Product Change Notice

(PCN Tracking Number: EE-QR-260422-08)

Customer:	All
Renesas Product Type:	SH2A Series (refer to product list on pages 3-4)
Description of Change:	The Final Test, Visual Inspection and Packaging processes will be transferred from Oita and Yonezawa factory to Nishiki Factory
Reason for Change:	To ensure stable supply and enhance competitiveness, Renesas back-end manufacturing factories are pursuing productivity improvements through process standardization, automation and specialization. As part of this initiative, Oita and Yonezawa factories will become assembly-dedicated manufacturing sites.
Identification:	Each product can be identified by T/C (Trace Code)
Schedules:	Correlation data: e/o Jul. 2026 (upon request) Requested approval: e/o Nov. 2026 Change implementation: b/o Jan. 2027 onwards
Anticipated Impact:	The change will have no impact on the fit, form, function, quality and reliability
Doc. No.:	EEQC-PCN-26-0025
Internal Reference:	PSD27-027-00

Packing Specification:

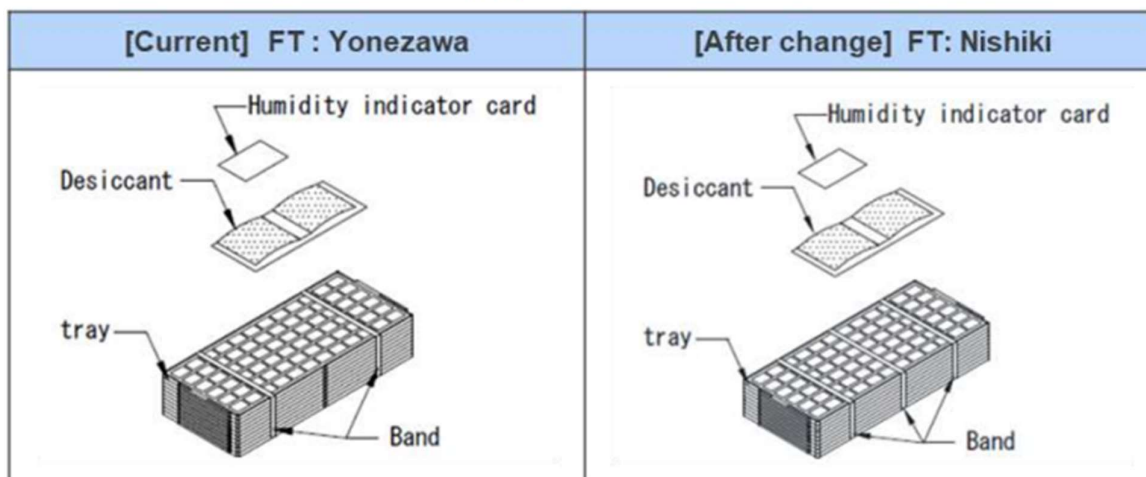
The packing specification of BGA products, LQFP product (Not applicable for JEDEC) will be changed (Change from 2 bands to 3 bands, see the following figures).
